July 7, 2022

Re: Proposed cell tower at Martin Rd

Exhibit A. SIMULATION - (View from Maynard Hill)

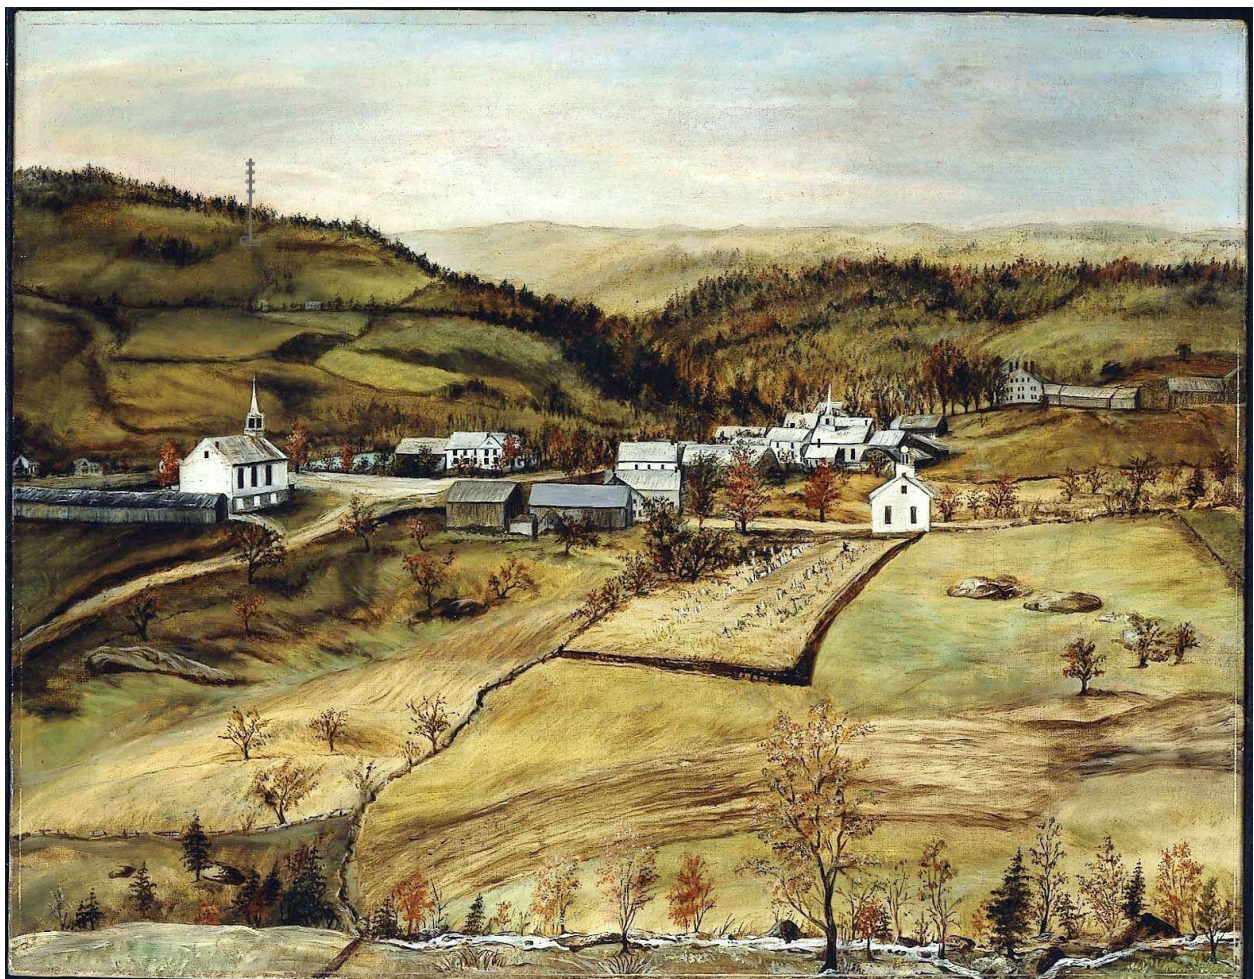
The proposed site and project ask for a tall tower which will be visible against the sky from most locations, and is not practical to disguise (realistically) because of its extreme height. It will require construction of a road that will also be visible from afar because of the challenging grade on the site. The site, while not historically significant itself, is still a critical pastoral and forest backdrop to many historic paintings and structures, and there is currently no visible development surrounding it. See *Exhibit A* as an example of the historical context. It is also visible from many homes, scenic areas and the Route 112 Scenic Byway.

However, if the cell tower must be placed on the given site, I ask that the applicant propose a shorter structure and make use of regionally-appropriate camouflage to conceal the tower against the forest backdrop. In this case, an Eastern White Pine tree concealment structure could blend as an above-average tall tree on this face. Since Eastern White Pine trees on hillsides do not typically exceed 100 feet, a tower height close to that could appear realistic. 150ft would be a truly monstrous pine tree for this hillside!

Exhibit C: Balloon demonstration on Jun 25, 2022 . Emphasis added for identification of balloon. Photo credit: John Holden

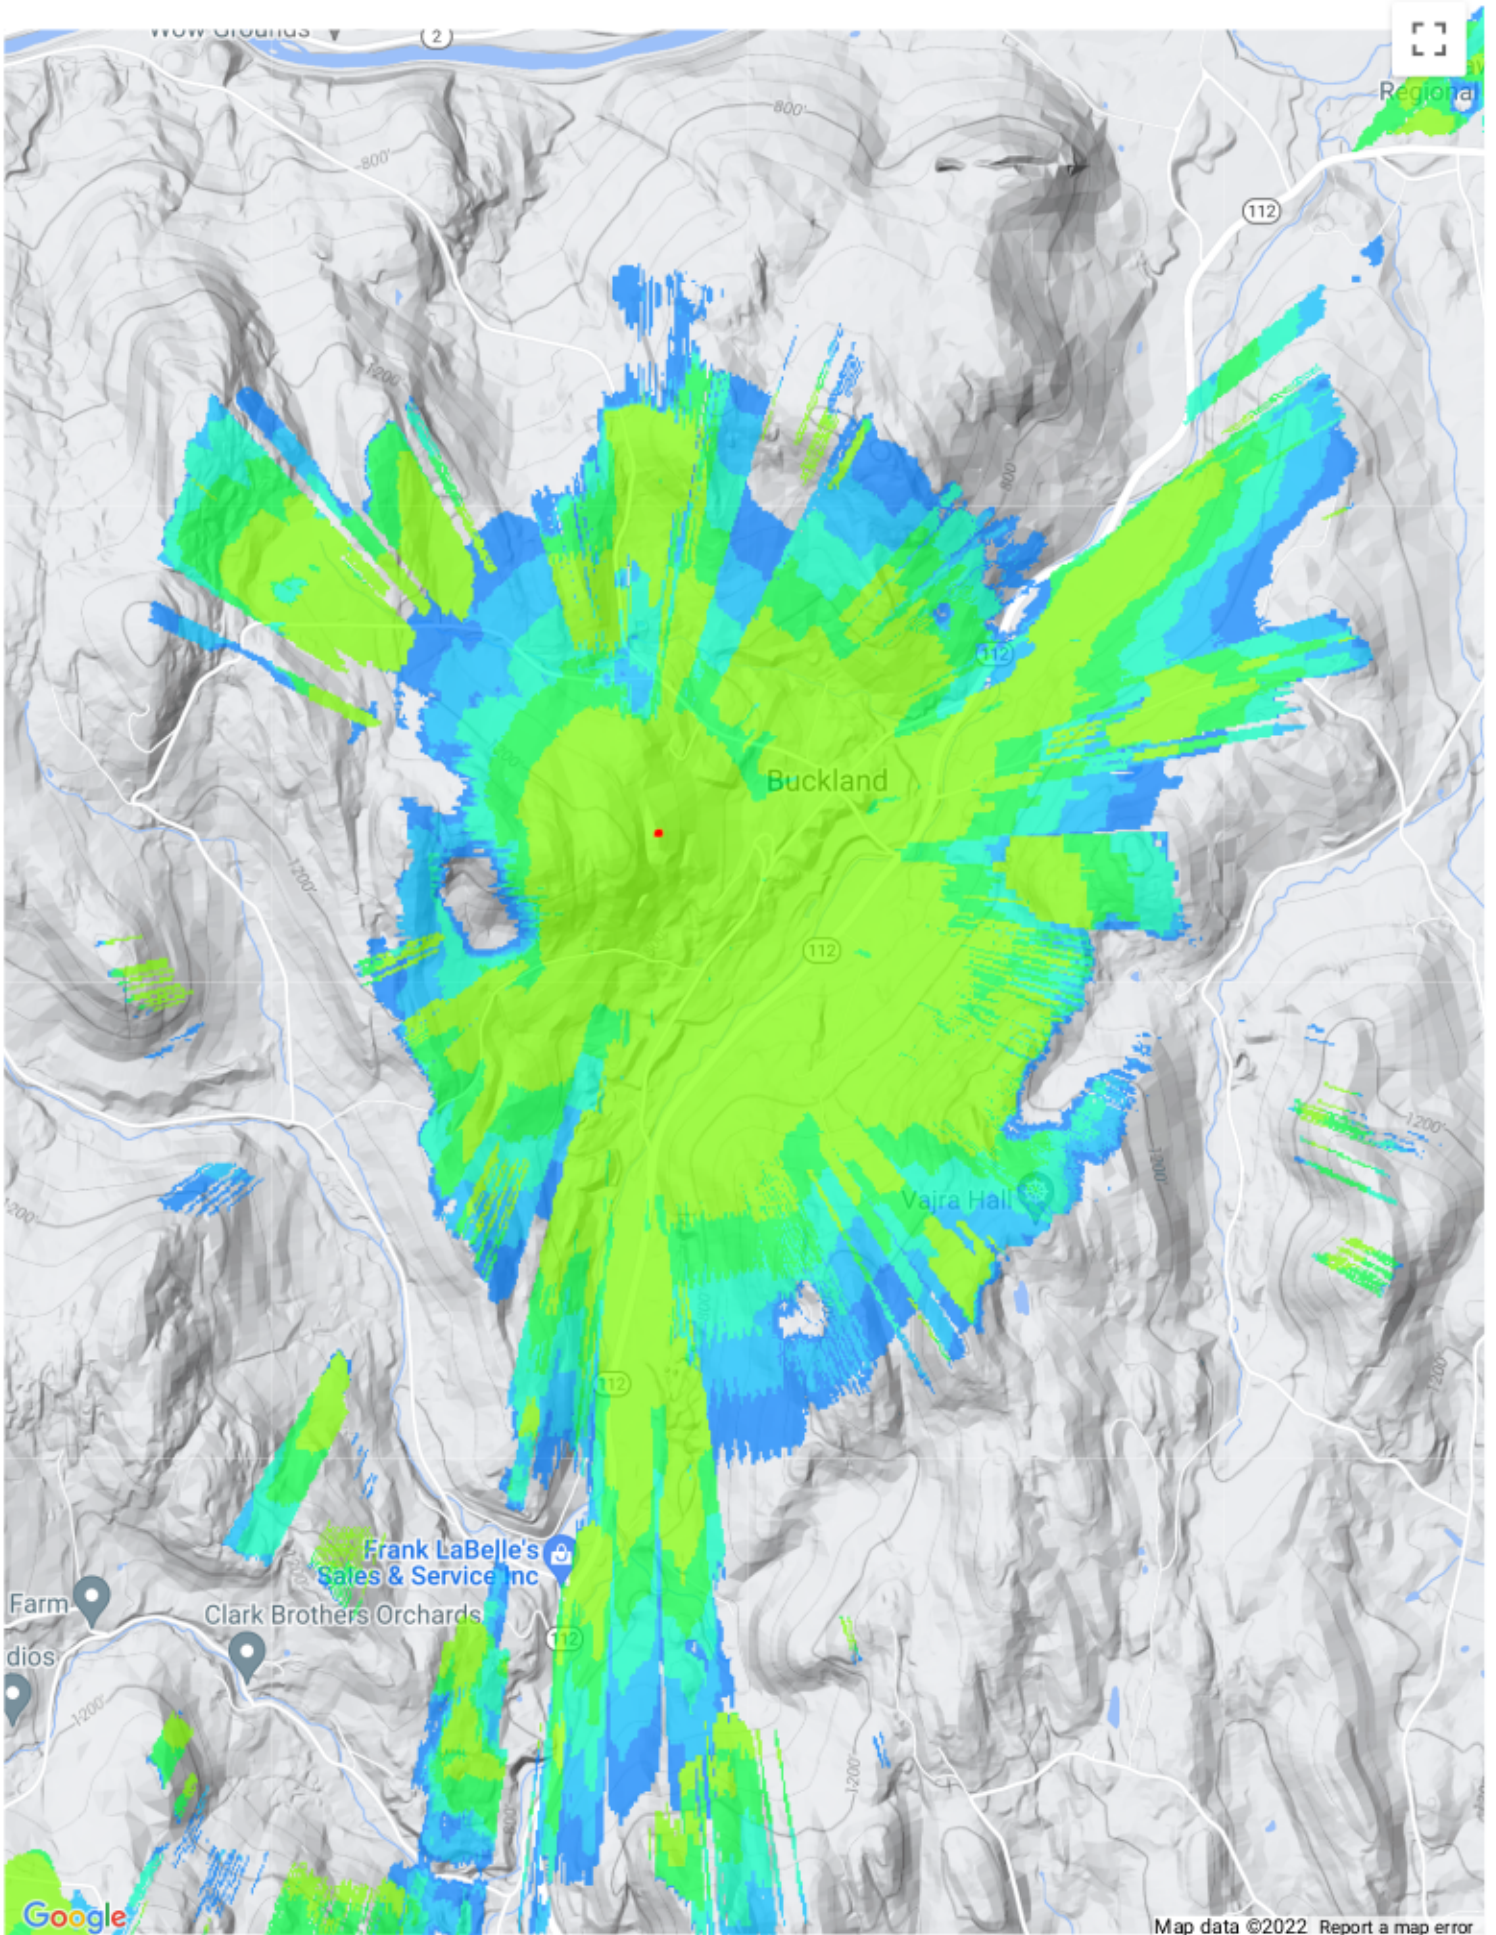
While the height is represented in photo simulations, I found that the balloon test – which was used to define the simulated tower height – was flown at notably different heights on different days (see *Exhibits B* and *C*). Because only a single balloon was used instead of 4 balloons along a line (to simulate the individual antenna bays/tiers) it is difficult to accurately represent both the scale of the simulation as well as the accuracy of the balloon height. For example, if multiple balloons were attached at a known spacing, the scale could be verified and understood in many photos. Because of this ambiguity I do not feel the balloon test was conducted in the spirit of the bylaw and makes it unreasonable to grant a variance for the proposed height without further study.

Similarly, in the required balloon flight demonstrations, there were noted variations in height from day to day, and in the simulations Vertex apparently chose the more optimistic "short height" days to demonstrations as the basis for their renderings where the tower image was superimposed. On one day for instance, the balloon was visible on 112 south of the proposed site; on another day it was not at all visible.
